Tech Info Library

DOS Compatibility Card: Sizzling Speaker Sound (4/96)

Tech Info Library Article Number: 18676

DOS Compatibility Sound Board

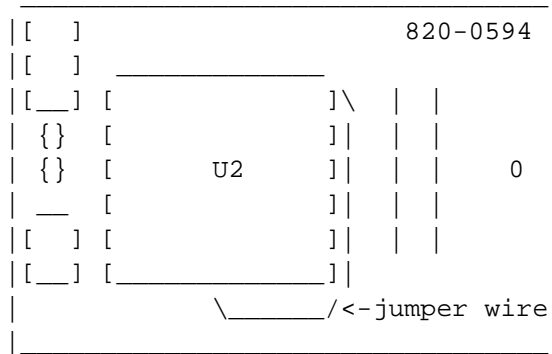
The problem is most likely caused by the Sound Board on your DOS Compatibility Card. Apple has taken steps to resolve this issue by implementing a change to the Sound Board to prevent this noise from occurring.

If you are unsure whether or not the Sound Board that you have has been revised refer to the figure below:

If the sound board has been revised it has a jumper from pin-79 to pin-24 (PDN) of the chip at location U2. If the jumper is not present, the board has not been revised.
